Addendum No. 001 (CORRECTED)

Subject: Boiler Plant Replacement Bid Package
General, Mechanical, & Electrical
SDP Contract No. B-108c/109c/110c of 2017/18

Location: Mastbaum High School
3116 Frankford Avenue
Philadelphia, Pennsylvania 19134

This Addendum, dated May 09, 2019, shall modify and become part of the Contract Documents for the work of this project. Any items not mentioned herein, or affected by, shall be performed strictly in accordance with the original documents.

DRAWING NO.
P-102
SHEET 19A OF 26

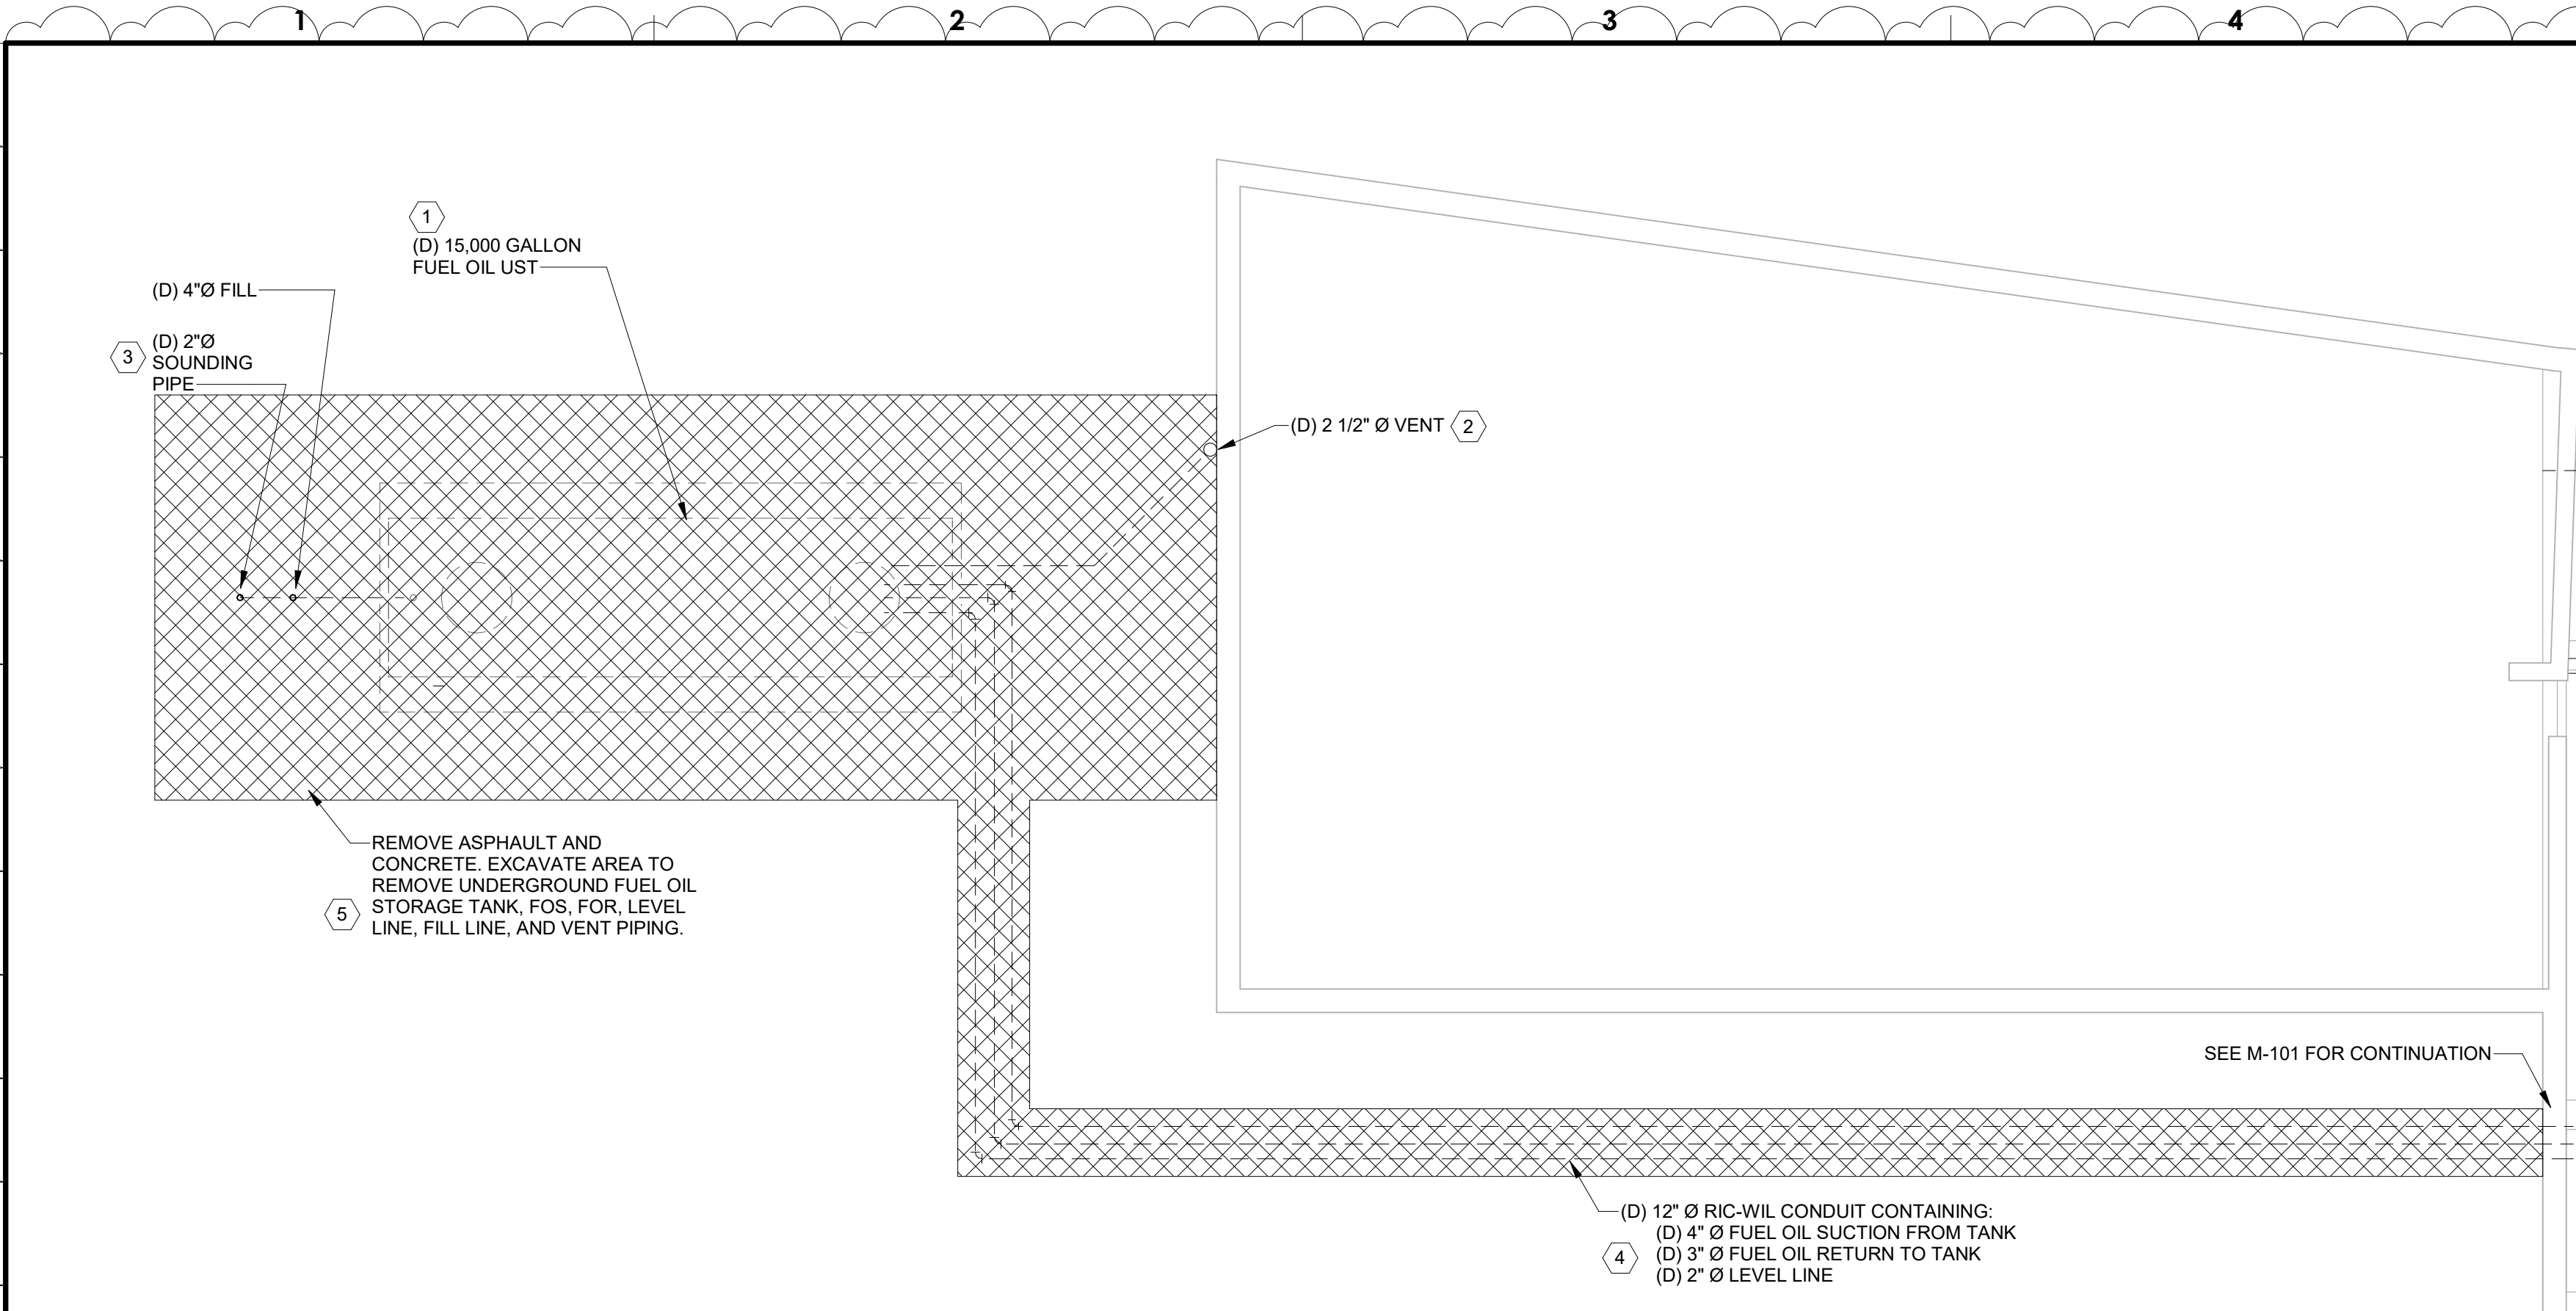
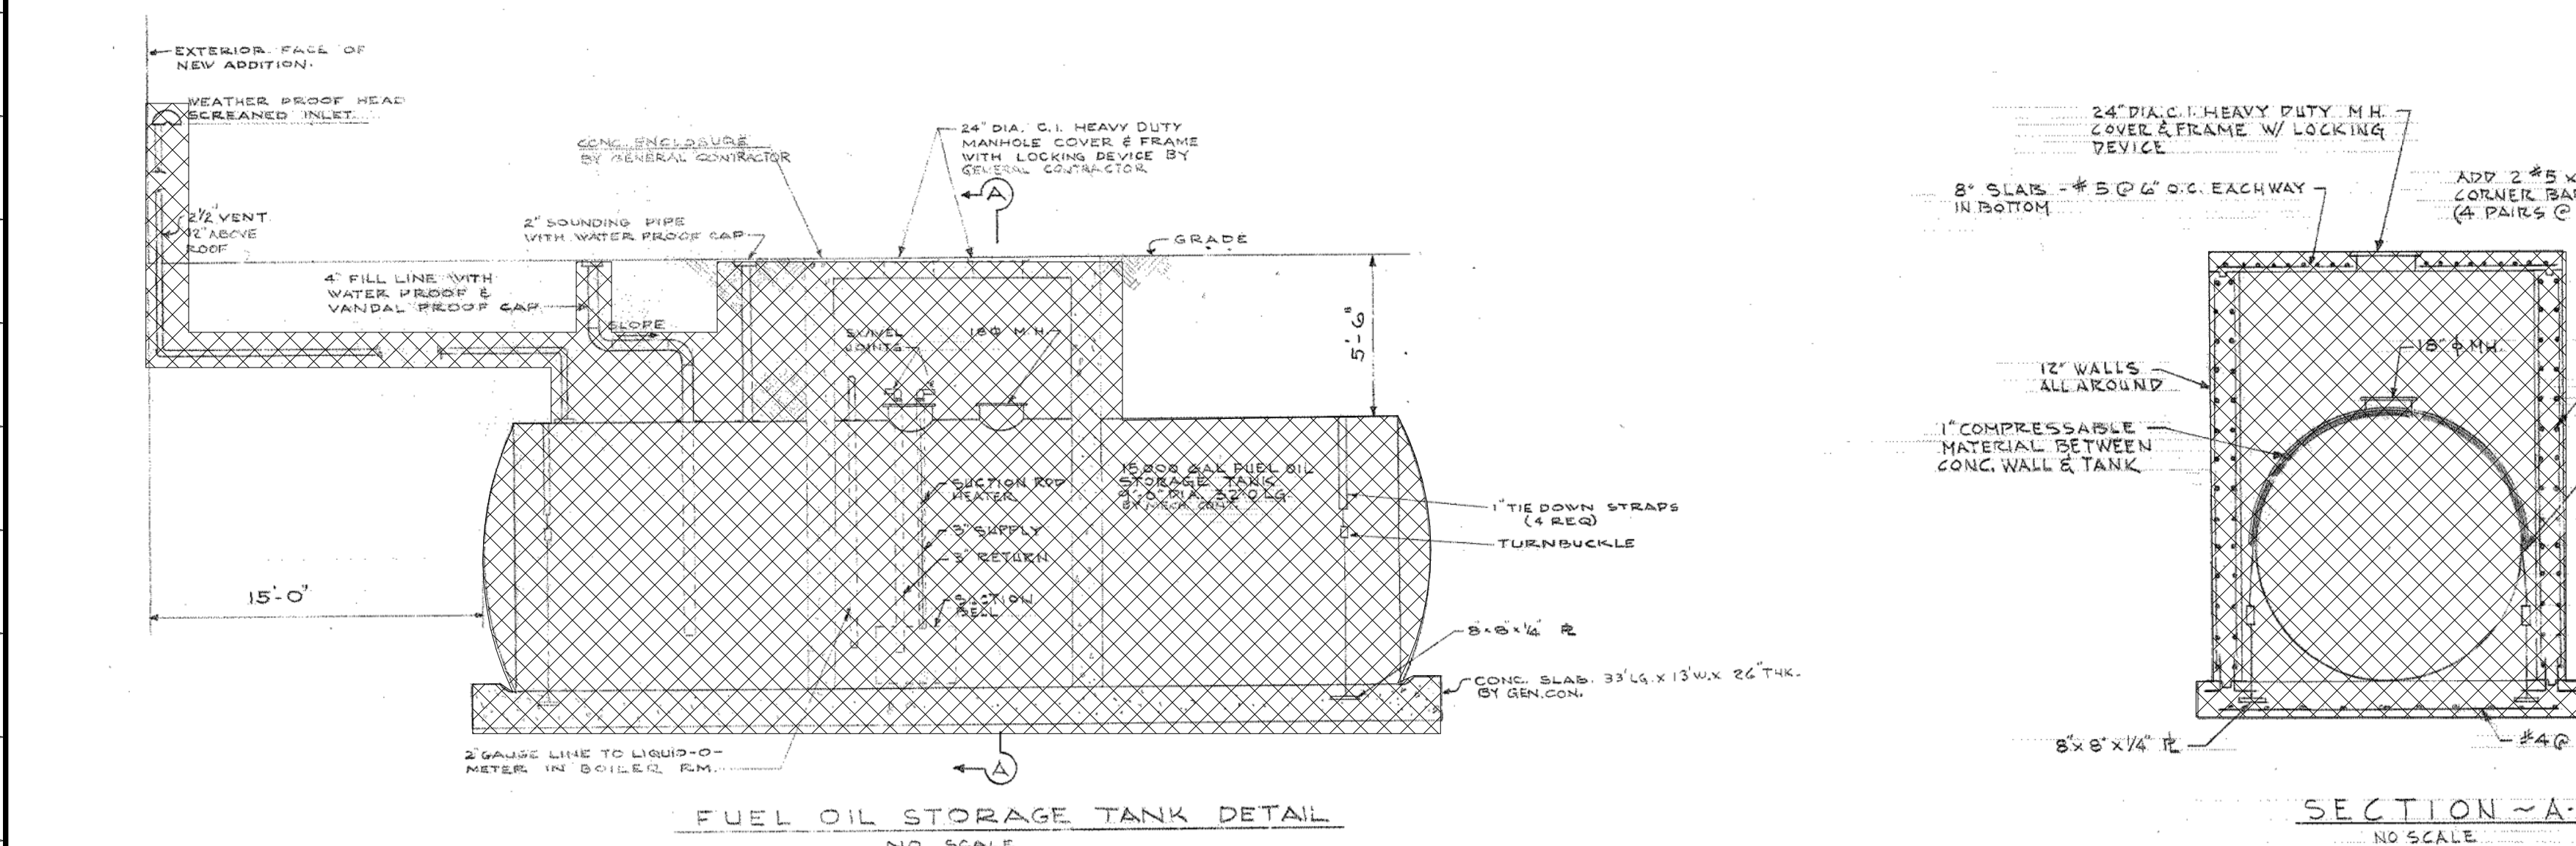
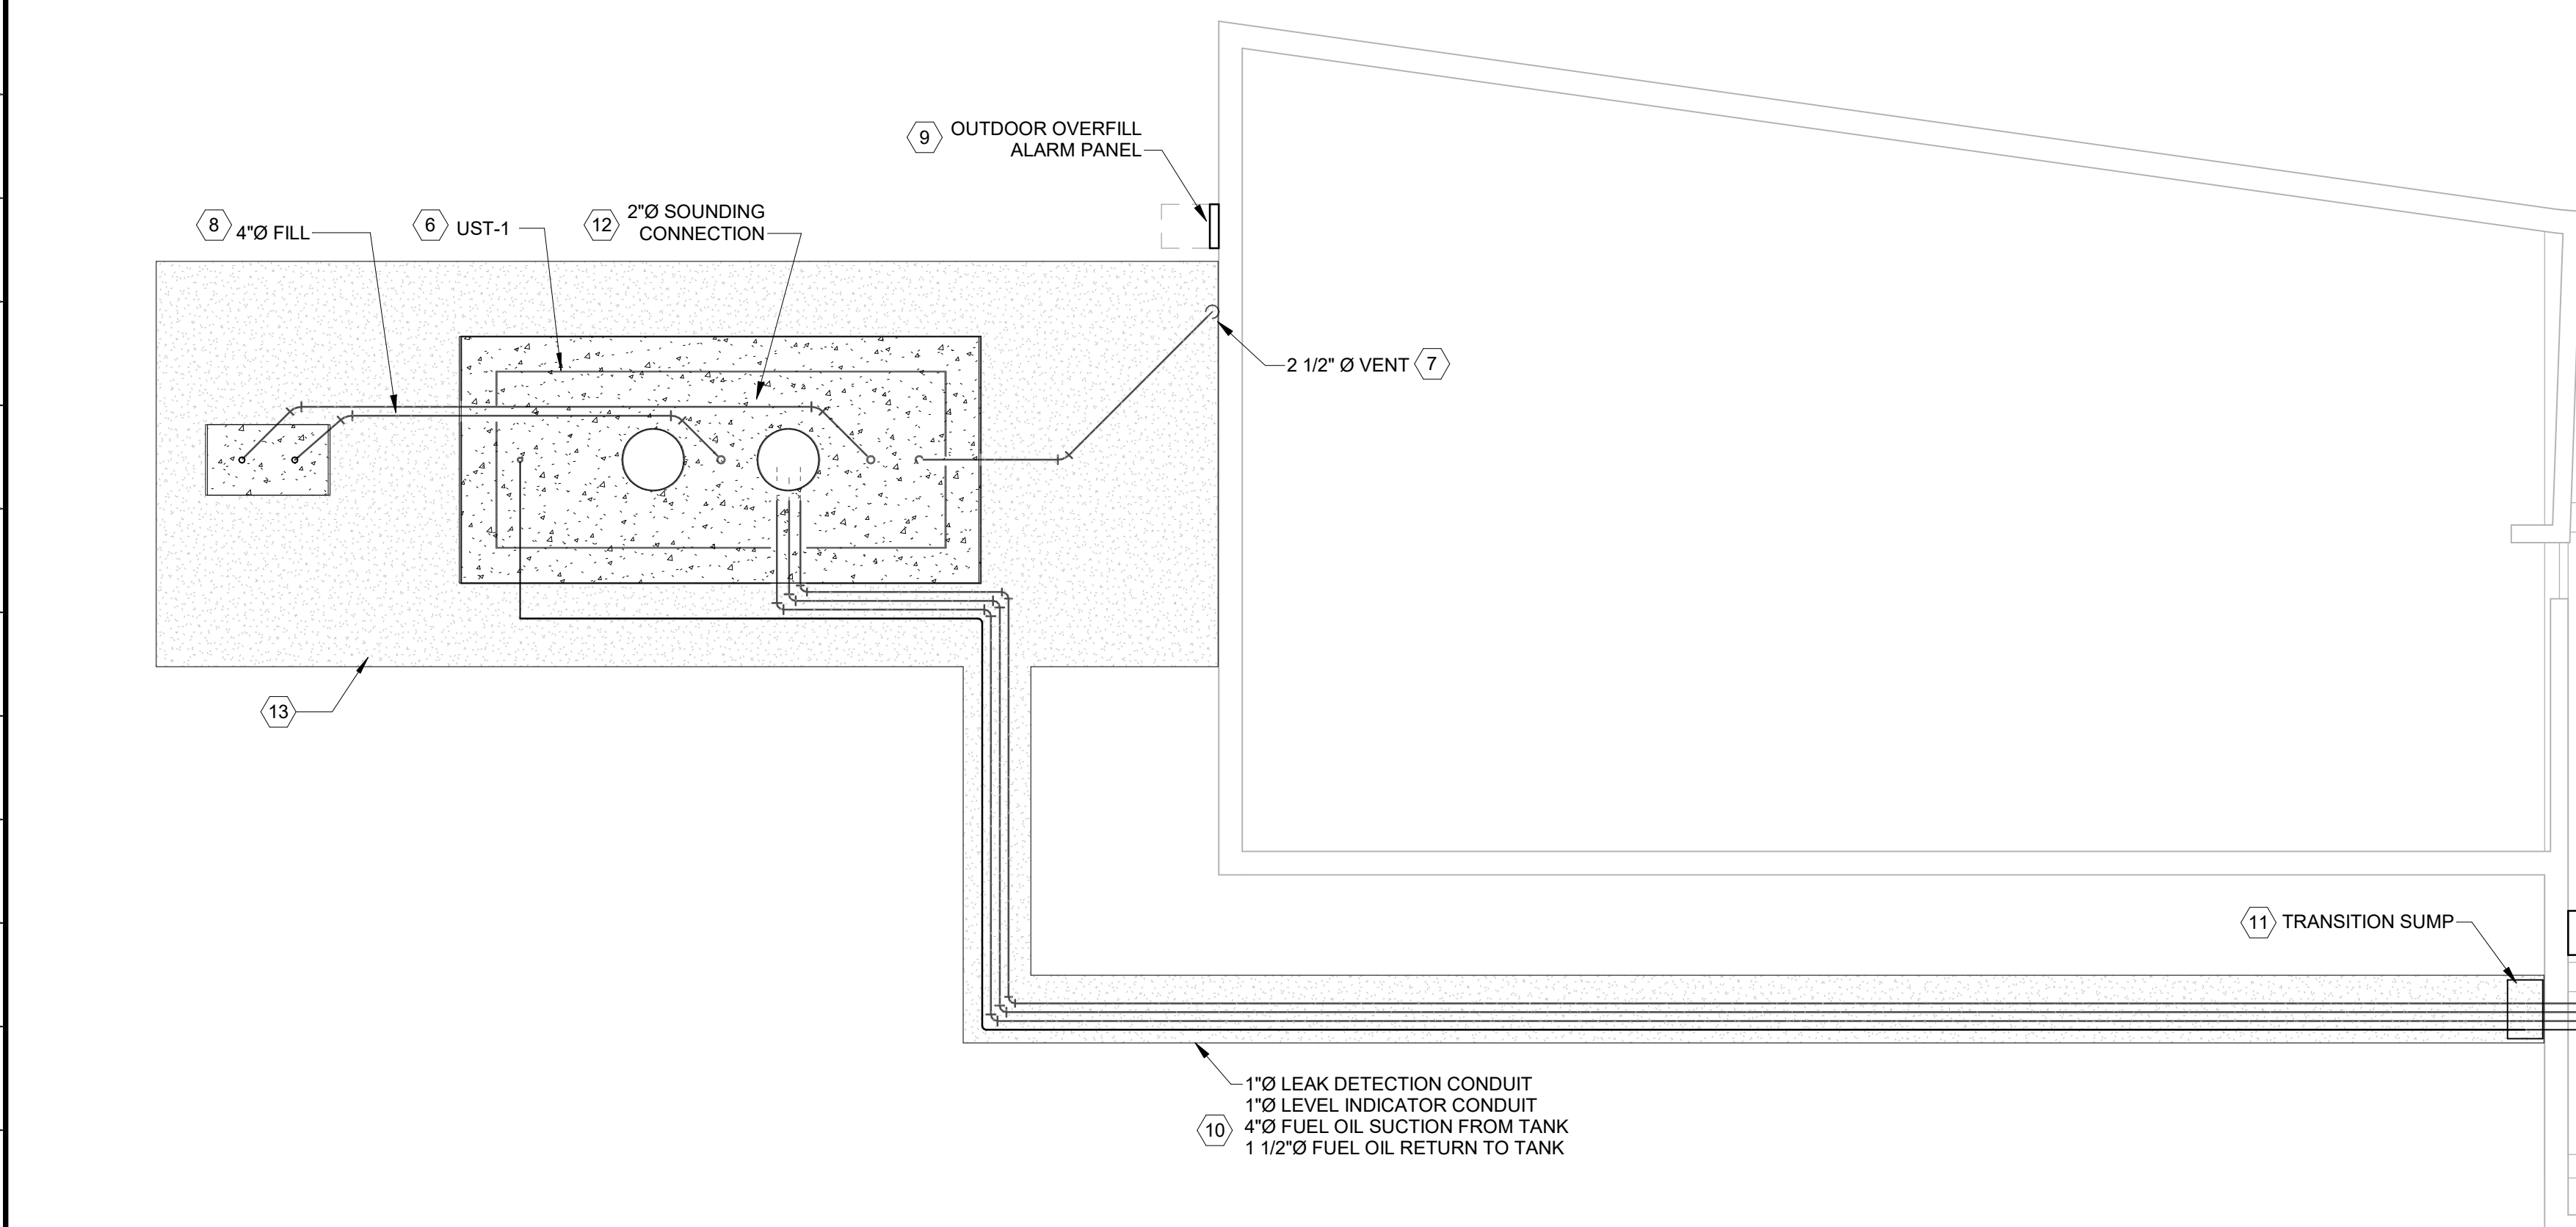
- 2.1.1 Drawing G-001: ADD Sheet P-102, Plumbing Fuel Oil Tank Demolition and New Work to the Drawing Index as Sheet 19A.

- 2.1.10** REPLACE P-101 with Addendum 001 Version. [See attached]
- 2.1.11** ADD Drawing P-102, Plumbing Fuel Oil Tank demolition and New Work [See attached]

- 2.1.12** Drawing E-401: ADD 120V wiring and conduit circuit from the remote overflow alarm panel to Panel PPBA. Refer to P-102.
- 2.1.13** Drawing E-401: ADD 120V wiring and conduit circuit from the level control system and secondary containment leak detection panel to PPBA. Refer to P-101.
